PRELIMINARY SITE PLAN UNIVERSITY / DOBSON

SEC OF UNIVERSITY / DOBSON - MESA, ARIZONA

RE: PLN2015-00294 & 295
1955 W. University Drive

Below, please find our responses to the review comments generated during your 1st review of the Site Plan and Design Review submittal.

SITE PLAN

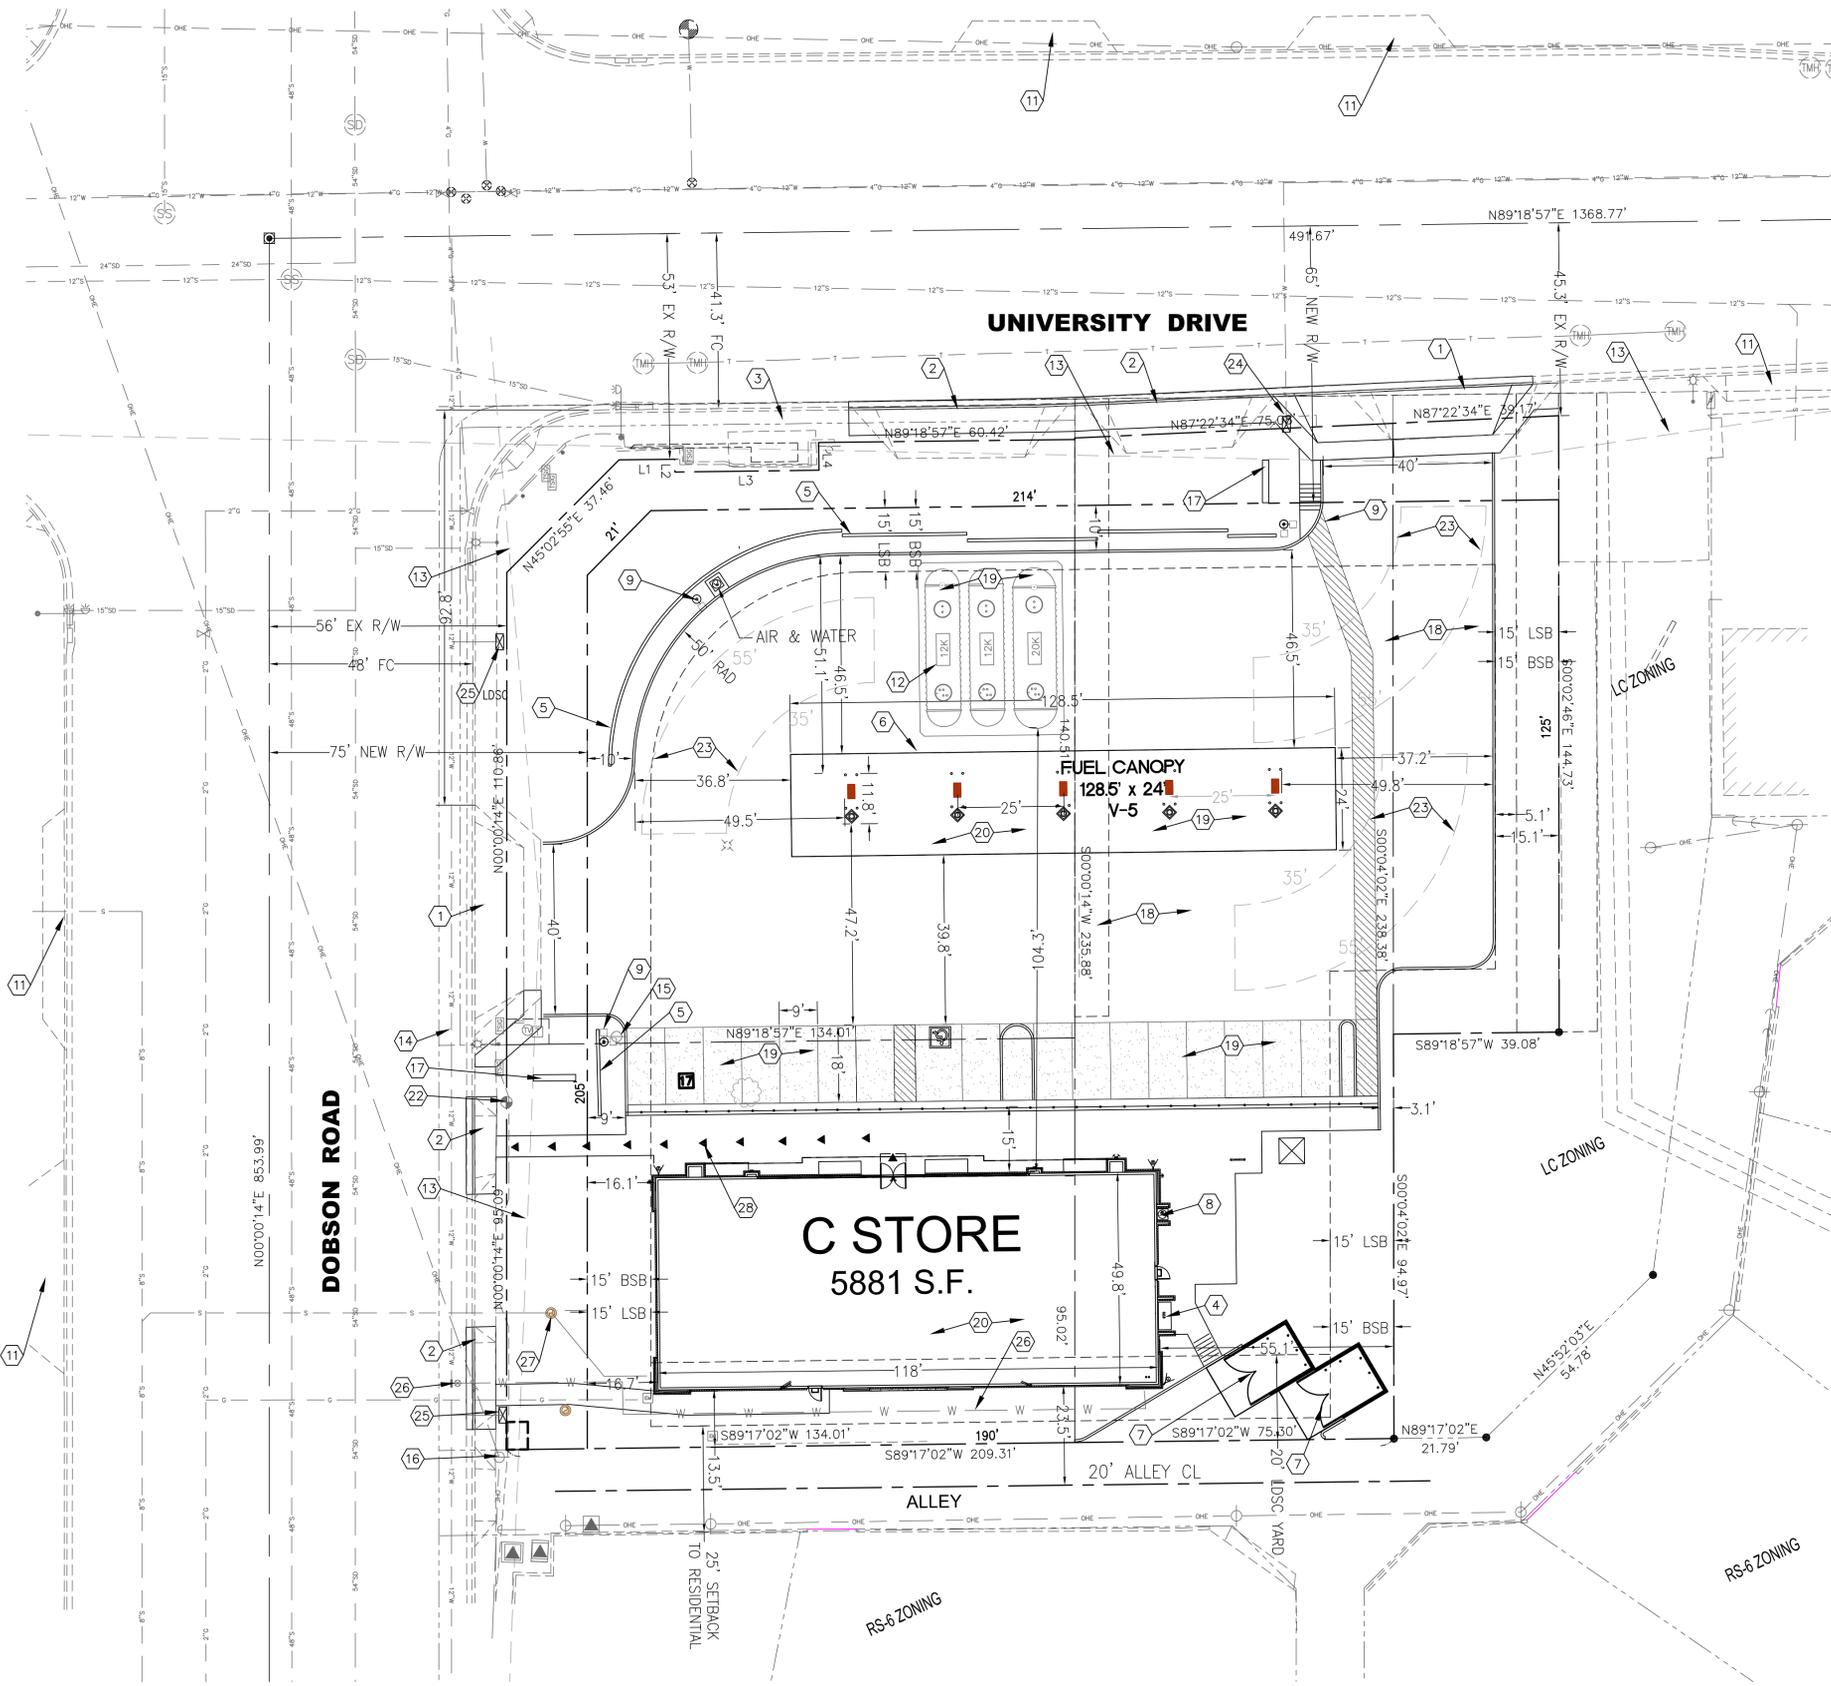
1. Site Plan
 - a) Show all future R.O.W. and street improvements per City of Mesa standards along Dobson & University Drive.

- b) Minimum Building/Parking Setbacks in the LC zoning district:
 - i) Along University from future 65' ROW: 15' shall be landscaped
 - ii) Along Dobson from future 75' ROW: 15' shall be landscaped
 - iii) South property line: Min. 20' shall be landscaped.
 - iv) East property line: 15' which shall be landscaped.

- c) The proposed site plan does not meet any current setback along any property lines.

- d) The site seems very small for the proposed facility with convenience and gas canopy at a major arterial intersection.

- e) The proposed redevelopment does not include the parcel to the east. The undeveloped parcel to the east has less than 36 feet wide frontage along University Drive, potentially making the parcel undevelopable for future use. The minimum lot width for LC zoning District is 100 feet.

- f) Staff recommends including the left over parcel to the east in the redevelopment proposal so the facility can be built per current City code and standards.

- g) Provide pedestrian connections to the transit stop and public sidewalks on University Drive per Section 11-30-8.

- h) Retention basin needs to be located outside future ROW and designed per current code Section 11-33-6.

- i) Staff recommends widening the foundation base in front of the store front door to include the parking lot depth by elimination at least two parking spaces to allow the customer properly transition from the interior of the store to the outside automobile/pump area.

- j) Total parking shall not be more than 125% of required spaces (15) per Section 11-32-3C.

- k) The proposed Service Station needs to be designed per Section 11-31-25 for landscaping, fencing, and lighting and update the project narrative with “good neighbor policy.”

- l) Monument signs need to be outside the ROW.

The existing and proposed ROW and proposed street improvements are shown on the revised Site Plan.

This project has applied for a Development Incentive Permit (“DIP”) which is requesting an overall reduction of the required landscape setback along all 4 property boundaries in order to accommodate the proposed redevelopment project. The site, as it is currently configured, provides very little landscaping as it is largely occupied by pavement and buildings. In addition, the proposed project requires right-of-way dedications on both University Drive (varies, 12 feet to 20 feet) and Dobson Road (17 feet) which further reduces the usable area for the redevelopment project. Therefore, the front (north) and side (west) landscape setbacks have been reduced from 15 feet (required) to 10 feet, the rear (south) setback reduced from 20 feet (required) to 13.5 feet and the interior side (east) setback reduced from 15 feet (required) to 5.1 feet. It should be noted that the property and use immediately east of this project is also zoned Limited Commercial and an access easement along the east 10 feet of parcel 135-63-123H prevents the installation of landscaping or improvements in this area. Circle K has modified their site plan in order to provide the 5.1 feet of landscaping.

Acknowledged. As stated above, this project has applied for a DIP.

Were it not for the required ROW dedications, the site would meet or exceed all City of Mesa development standards. Due to the ROW dedications, Circle K has applied for a DIP which would allow them to redevelop the site with some relief on the required building/landscape setbacks.

The parcel to the east is existing and is owned by a different entity than the owner of the parcels Circle K is redeveloping.

Circle K has contacted the owner of the parcel to the east and is unable to reach an agreement to purchase the parcel.

A pedestrian connection has been provided to both University Drive and Dobson Road.

All retention basins are located outside of the future ROW and are designed per current code Section 11-33-6.

The Site plan provides for 15' from the front of the store to the beginning of the parking lot. In addition, the front doors of the store are aligned with the accessible space striped area which provides for an additional 18 + feet of space (for a total of 33') for the customer to transition from the interior of the store to the outside automobile/pump area.

Per the revised Site Plan, 16 spaces are required and 17 spaces are provided. Therefore, we meet the requirements of Section 11-32-3C.

The project has been designed to meet the requirements of Section 11-31-25 for landscaping (modified per the DIP request), fencing (masonry block walls) and lighting. In addition, the project narrative has been updated with the “good neighbor policy.”

Circle K will be requesting a License to place the monument signs within the ROW. On previous projects, Circle K was granted a license to place the monument sign in the ROW with the understanding Circle K will be responsible to remove/relocate the sign if improvements are required in the ROW.

1 "REAR" SOUTH ELEVATION
SCALE: 3/16" = 1'-0"

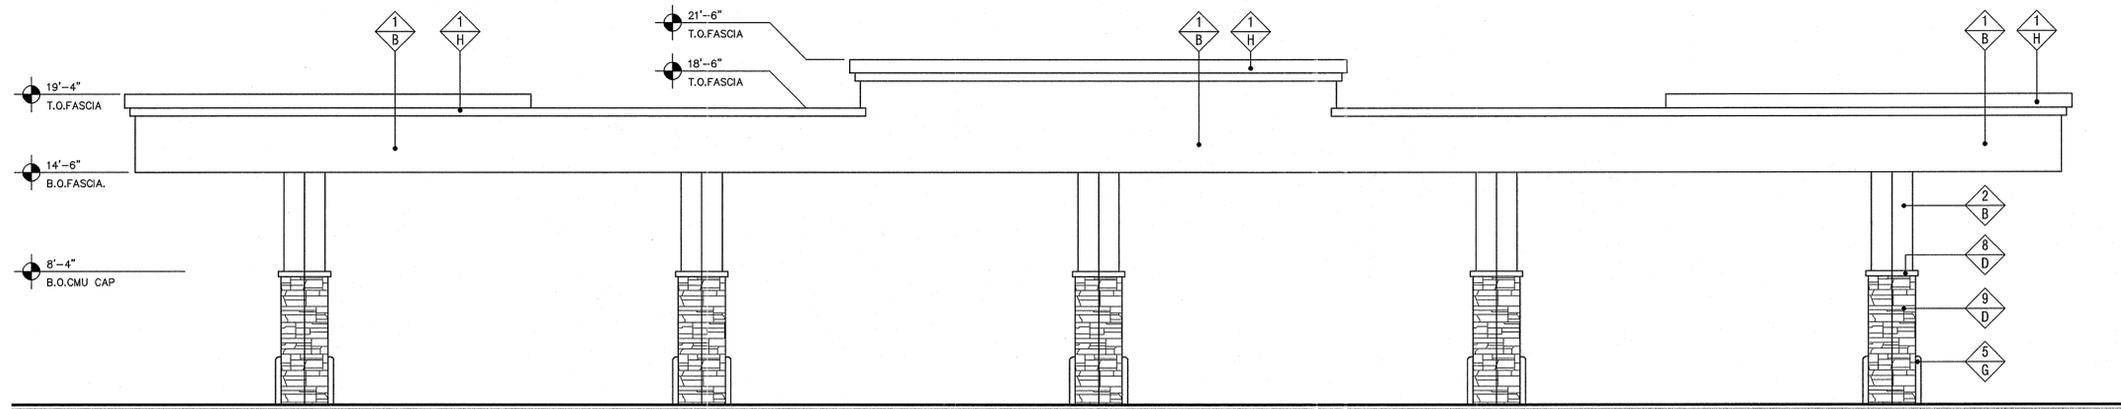
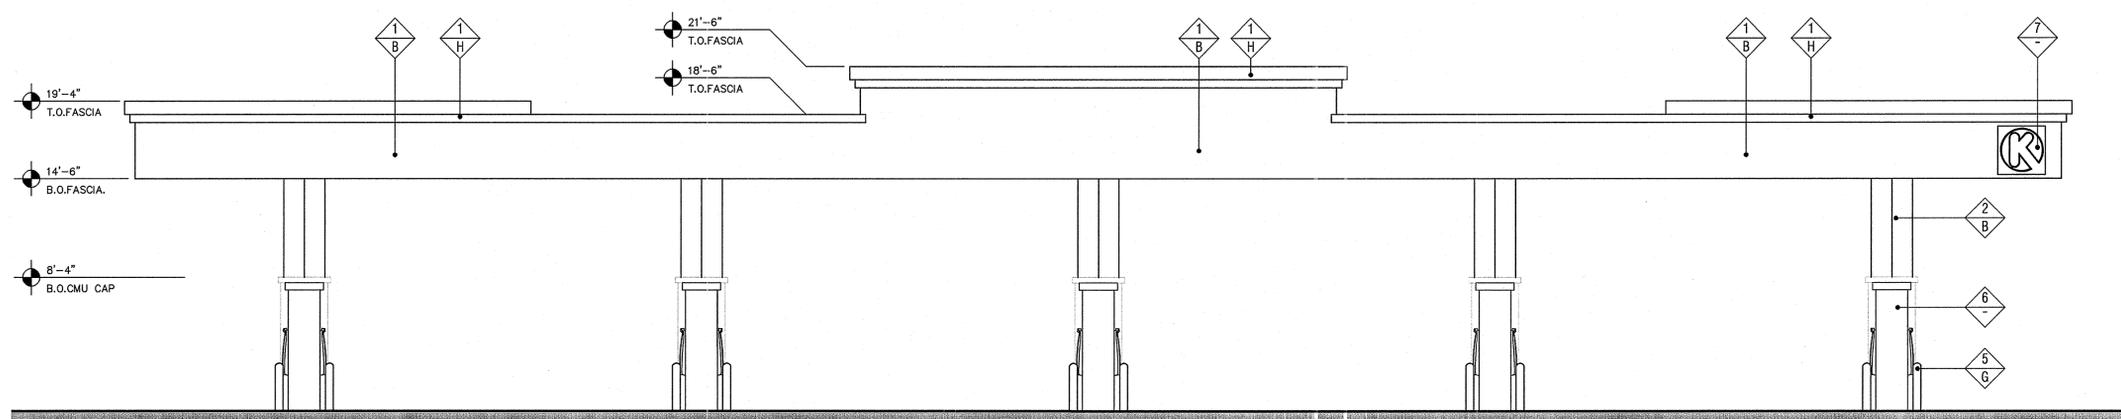
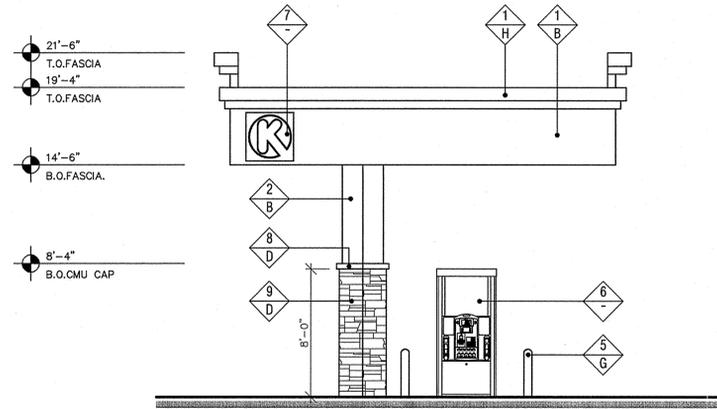
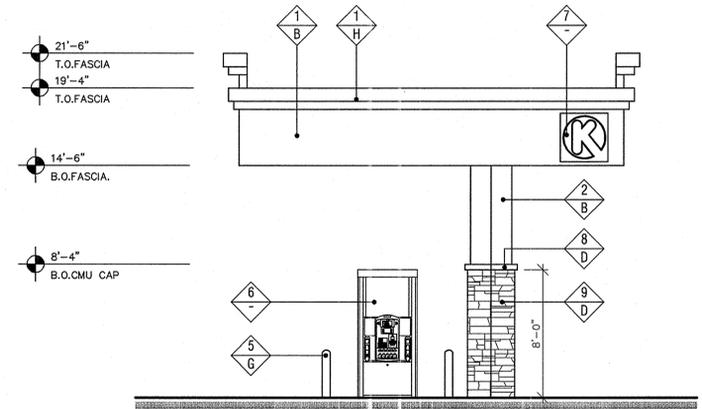
- a) The gas canopy needs more articulation with design, material and texture.

The gas canopy has been modified and now includes architectural features found on the Circle K Store building.

1 FRONT ELEVATION (NORTH)

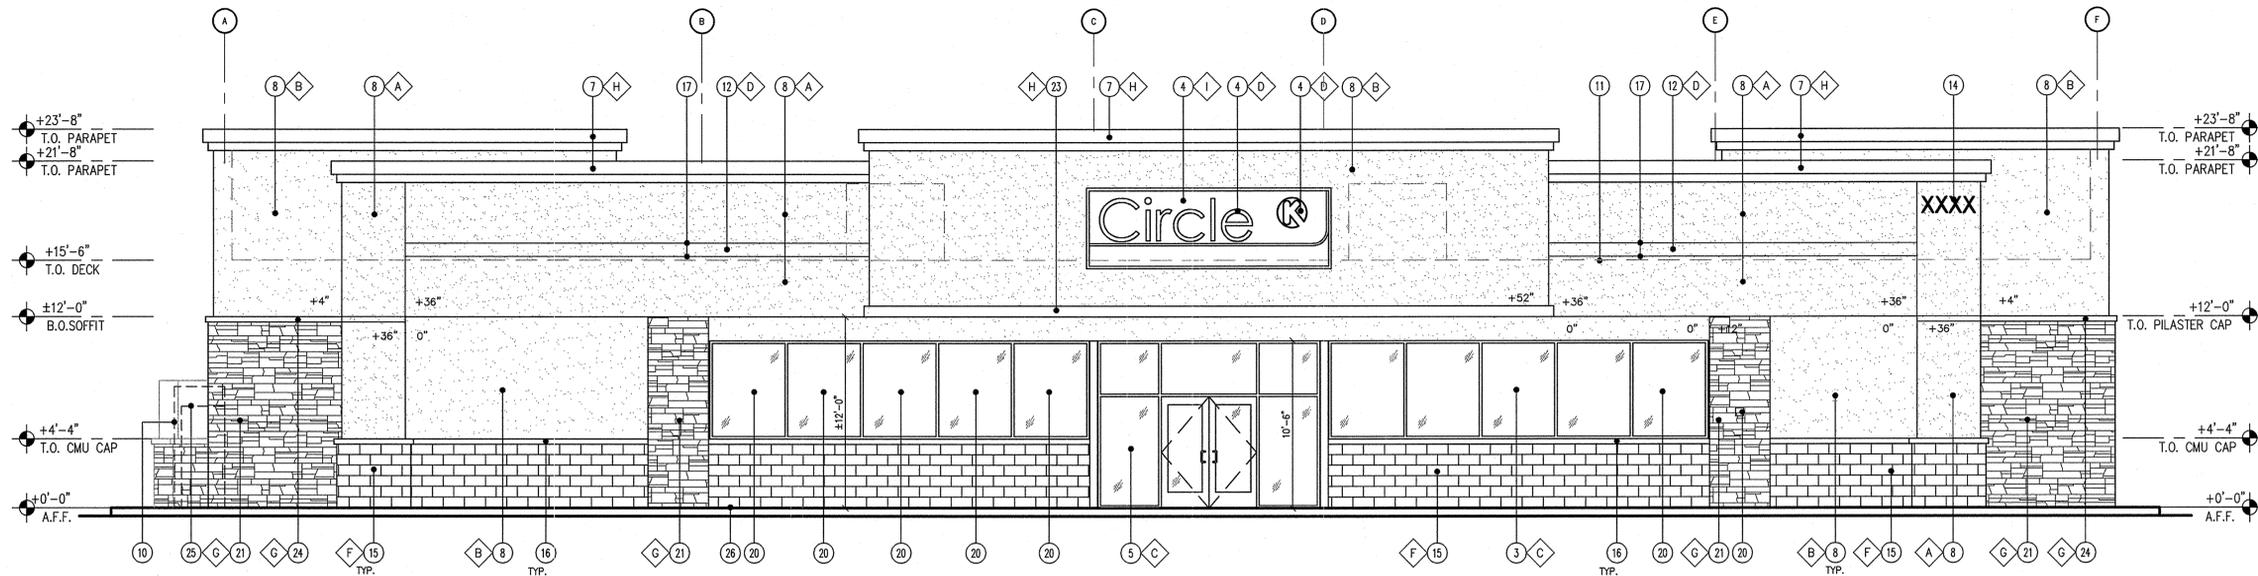
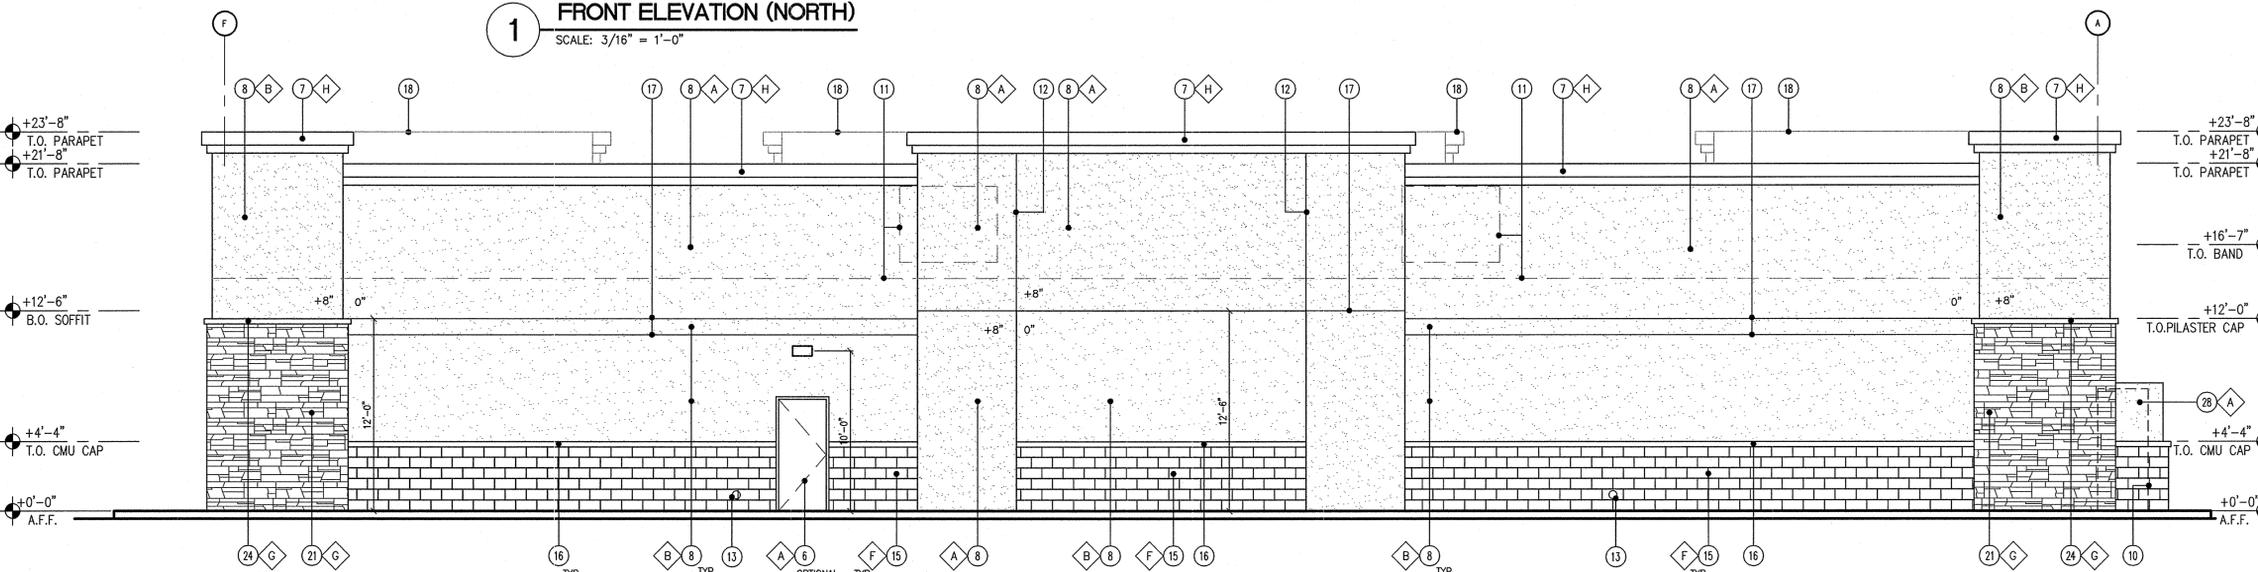
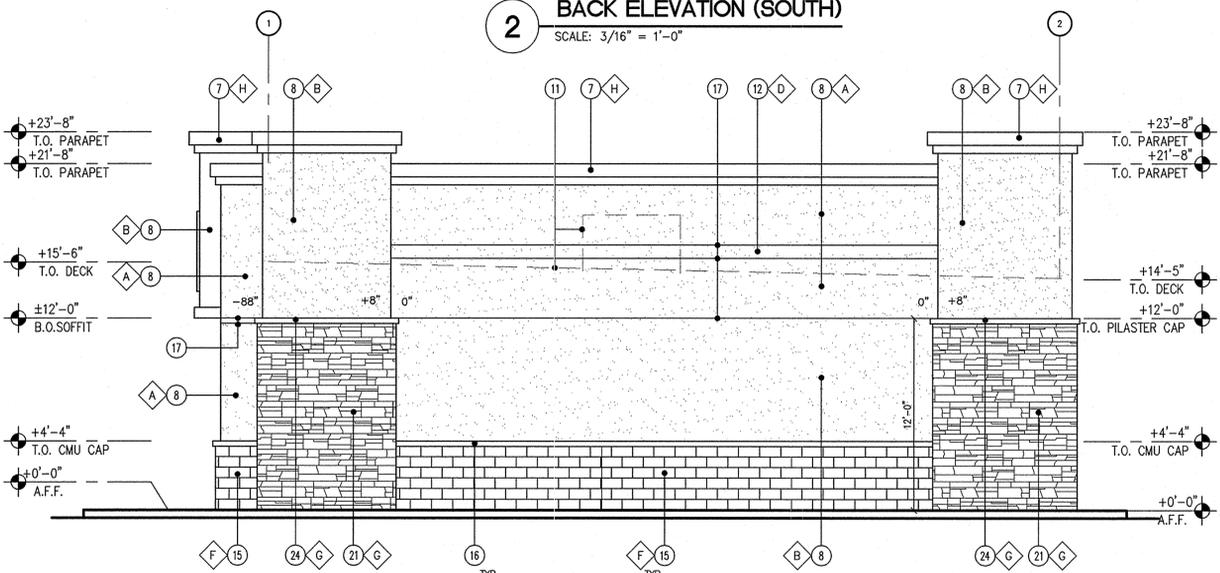
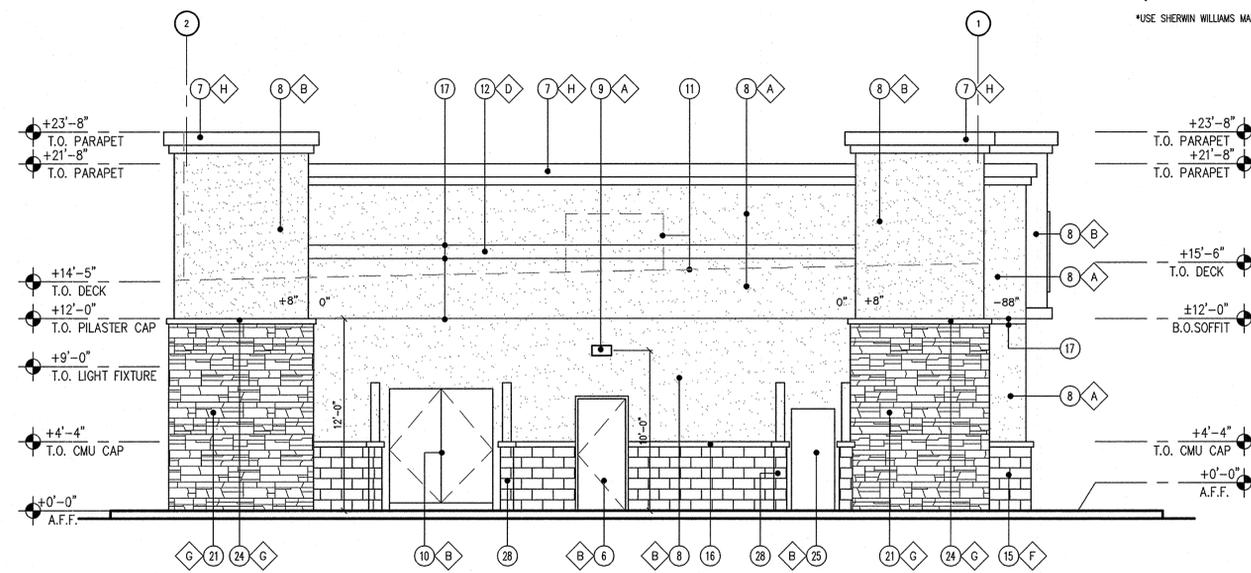
- b) Store front architecture looks flat and needs more variation, enhancements and prominence.

- c) Shade at Entries: at customer entrances, pedestrian walkways shall be provided with weather protection such as canopies, awnings, arcades and trellises (Section 11-30-8F).

d) Show roof top mechanical equipment with dotted lines on elevations.

e) The end elevations facing east and west needs more articulations.

The front façade of the store has a significant amount of variation and enhancements. The planes of the building move from 0”, 4”, 12”, 36” and 52” and has 3 different materials (cultured stone, masonry block and stucco).

The front entry provides shade and weather protection for customers as it projects out from the building 52”.

Rooftop mechanical equipment has been shown on the elevations with dotted lines.

The east and west elevations have been modified with varying planes, colors and materials.
